RESPONSE TO REQUEST FOR ADDITIONAL INFORMATION

APR1400 Design Certification

Docket No. 52-046

RAI No.: 116-8054
SRP Section: 14.03.08 – Radiation Protection Inspections, Tests, Analyses, and Acceptance Criteria
Application Section: Tier 1, Various Sections
Date of RAI Issue: 07/27/2015

Figure 2.7.2.5-1 Equipment and Floor Drainage System

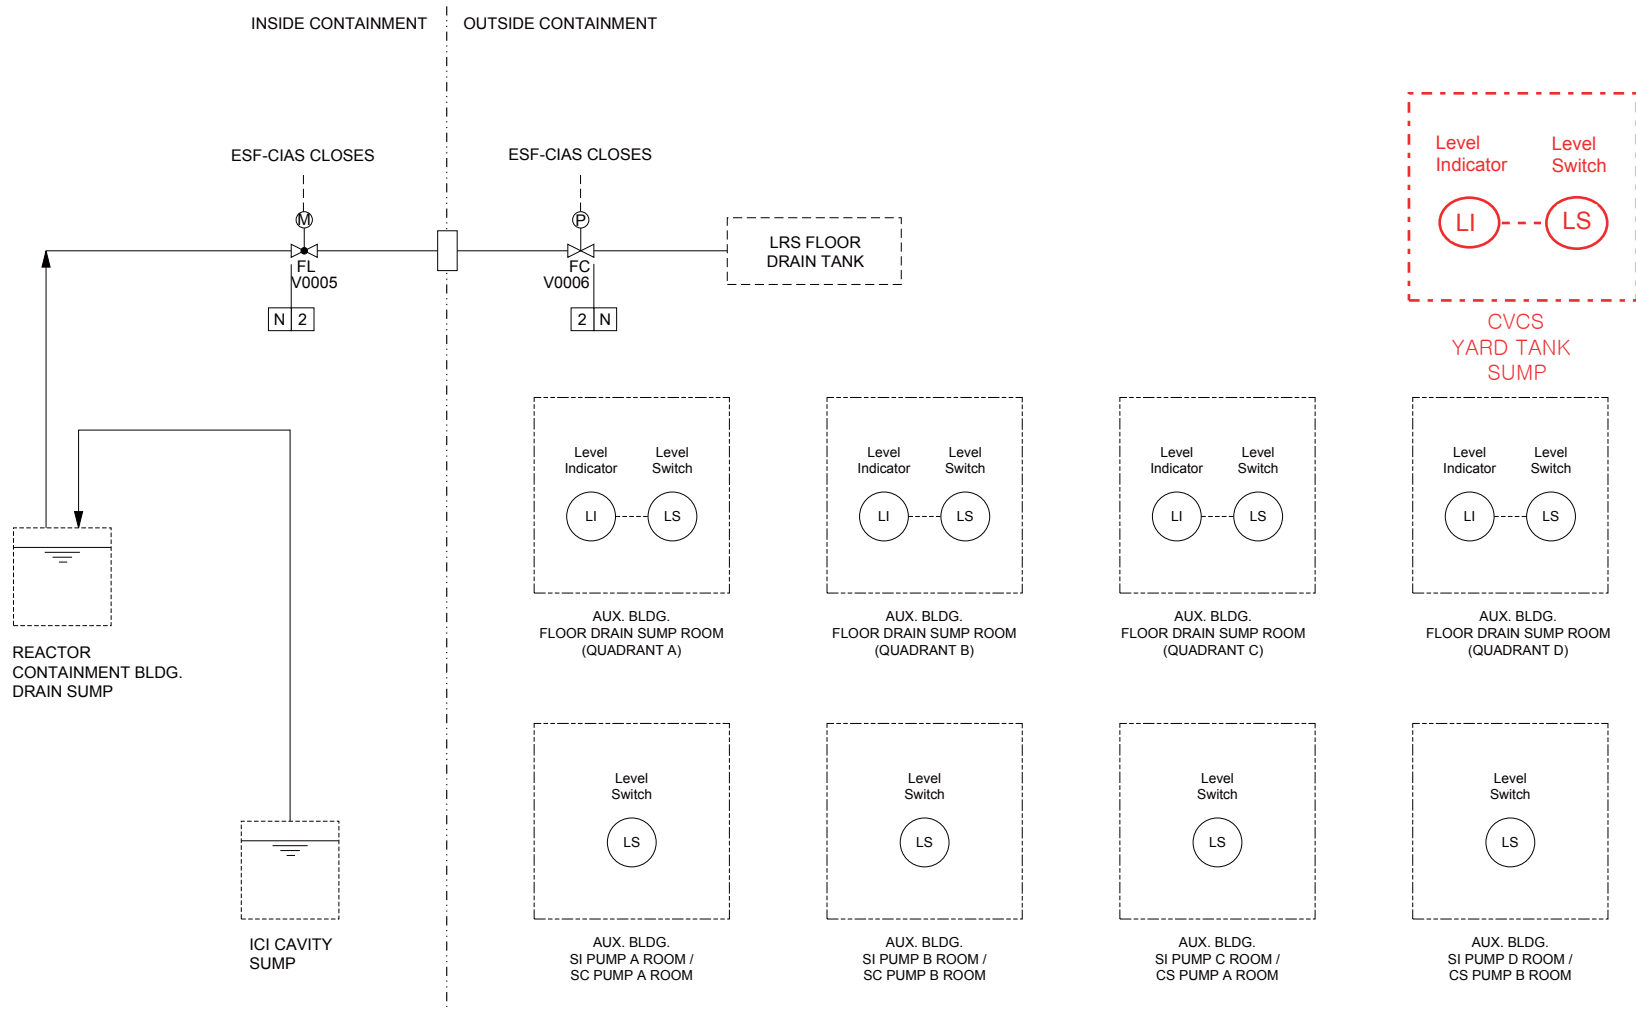
In reviewing Tier 1 ITAAC, staff could not find any ITAAC for design features to minimize contamination. In accordance with 10 CFR 20.1406(b), please provide ITAAC for significant design features to address leaks from high specific activity fluids (such as Reactor

Coolant System water, Spent Fuel Pool coolant or concentrated liquid waste) or from high volume, low specific activity fluids (such as diluted liquid radioactive waste).

CVCS is designed to comply with 10 CFR 20.1406 as discussed in DCD Tier 2 Subsection 9.3.4.2.10. The holdup tank, boric acid storage tank (BAST), and reactor makeup water tank (RMWT) are located outside in a tank house which is designed with a sloped floor coated with epoxy to facilitate draining and cleaning. The tank house is equipped with a sump that contains level switches to detect leakage and overflow. This leak detection design feature is considered significant and additional ITAAC will be added to DCD Tier 1 Subsection 2.7.2.5 Table 2.7.2.5-4 as presented in Table 3 below.

Design Commitment	Inspections, Tests, Analyses	Acceptance Criteria
9. Leak detection design for the tank house sump for holdup tank, BAST and RMWT provides an alarm in MCR of liquid detection	9. Inspection of the as-built leak detection system and signal test is conducted to verify the alarm in the MCR.	9. A report concludes that the as-built leak detection is installed as designed; and concludes that the alarm is consistent with the setpoint.

CVCS yard tanks
